**Oshawa Active Transportation  
Advisory Committee  
Meeting Agenda**

**Wednesday, April 5, 2023, 6:30 p.m.  
Committee Room**

**Subject:** Integrated Columbus Part 2 Planning Act and Municipal Class Environmental Assessment Act Study

**Subject:** Durham Meadowway Visioning Study

Exhibit 1

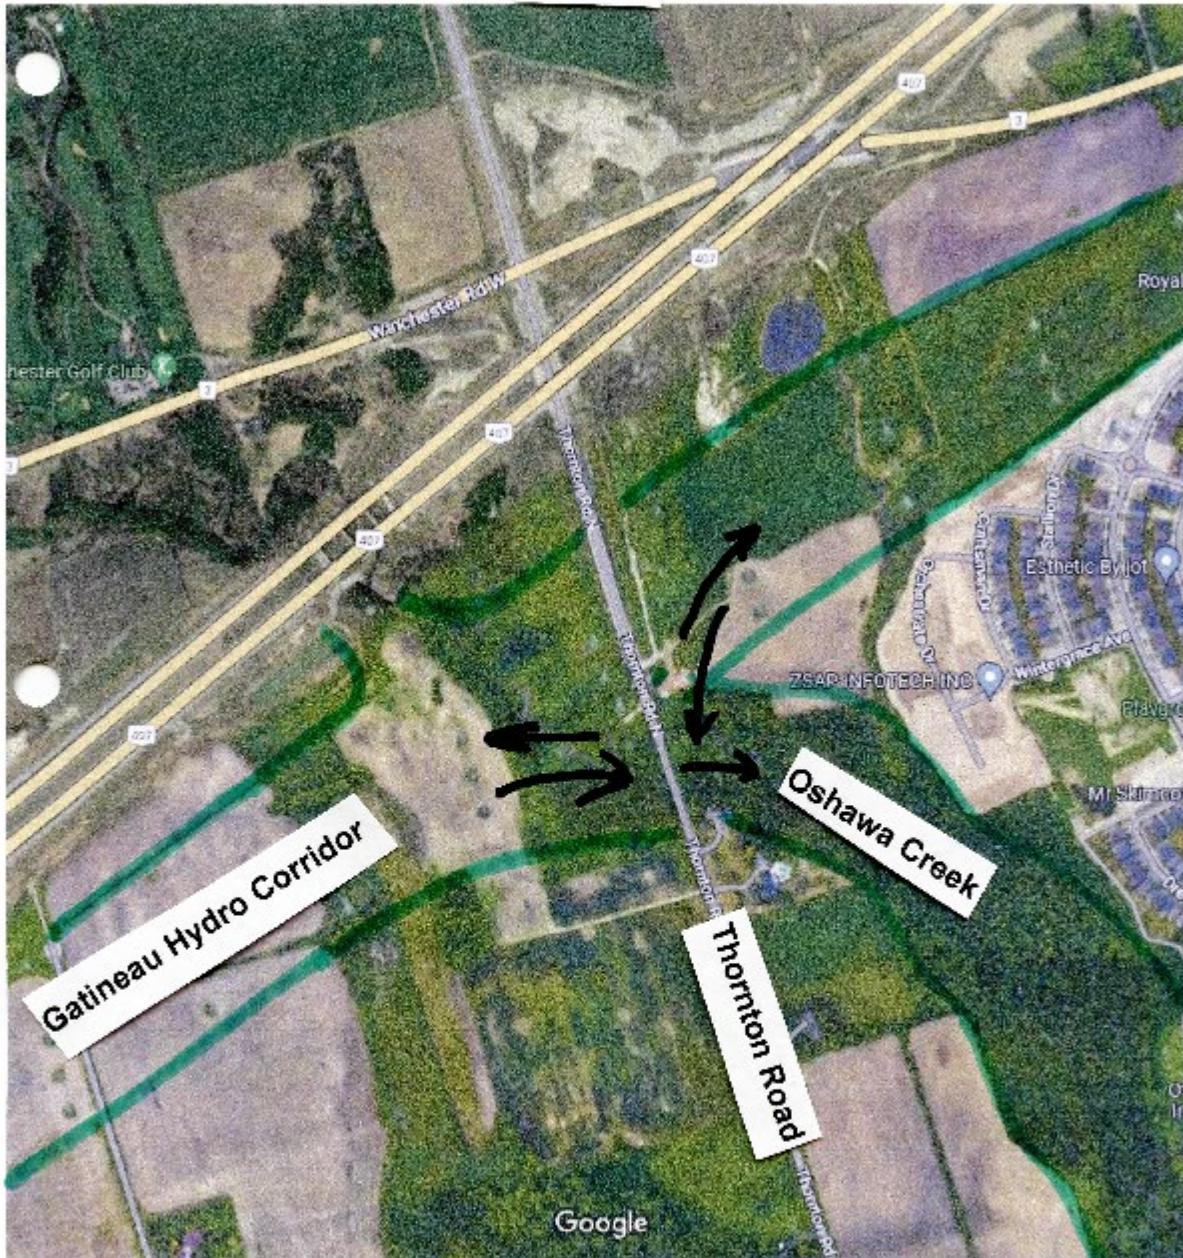
- 2.2 That the City request the consultant for the Thornton Road design to provide an estimate of the cost of providing a grade separated underpass for walking and cycling under Thornton Road for both the users of the Oshawa Creek Valley and Gatineau Hydro Corridor. Exhibit 1.

- 3.2 Thornton Road is the most westerly road intersecting this hydro corridor in Oshawa. The road is under design for both a two and four lane cross-section. One branch of the Oshawa Creek Valley runs under Thornton Road adjacent to this hydro corridor. The opportunity exists to design the Oshawa Creek underpass of Thornton Road to accommodate both the Oshawa Creek trail users and the Hydro Corridor patrons. The consultants for the Thornton Road design should be requested to identify the cost of providing a grade separated crossing for active transportation in the Oshawa Creek Valley to accommodate both trail users.
